Ferrari North America

Technical Information

Date: January 2019
Bulletin #: 2545
Campaign #:
Supersedes:
Section: 10

Model Type: F12 Berlinetta
Model Year: All
Subject: Update of Spare Parts Catalog Table

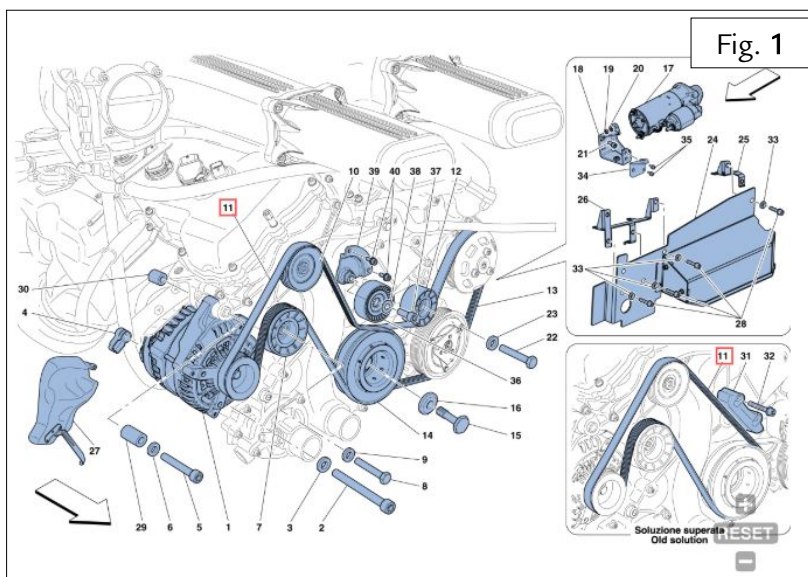
We would like to inform you that with the latest update of the Online Technical Documentation, table number **43** of the F12 Berlinetta Spare Parts Catalog has been modified, in order to clarify the combination between the spare part number and the engine number for reference **11** – Fig.1.

Reference **11** foresees the different types of belts, in relation to the engine number. The combinations between the spare part and the engine number are shown in the following table.

Engine number	Code of the belt to be fitted	Belt tensioning system
Up to engine No. 242122.	No. 314330 BELT	Apply new solution, <u>Order the following additional components:</u> Support No. 294538 ref. 39 Belt tensioner No. 294613 ref. 36 Screw No. 14307434 ref. 37 Washer No. 12642524 ref. 38 Screw No. 248334 ref. 40
From engine No. 242123 to engine No. 304140	No. 314330 BELT	Do not change configuration
From engine No. 304141.	No. 318332 BELT	Do not change configuration

Pay attention to fit the correct belt combined with the correct belt tensioner system, respecting the indications given in the table. Any problems resulting from incorrect configuration may not be covered under the vehicles warranty or extended service coverage.
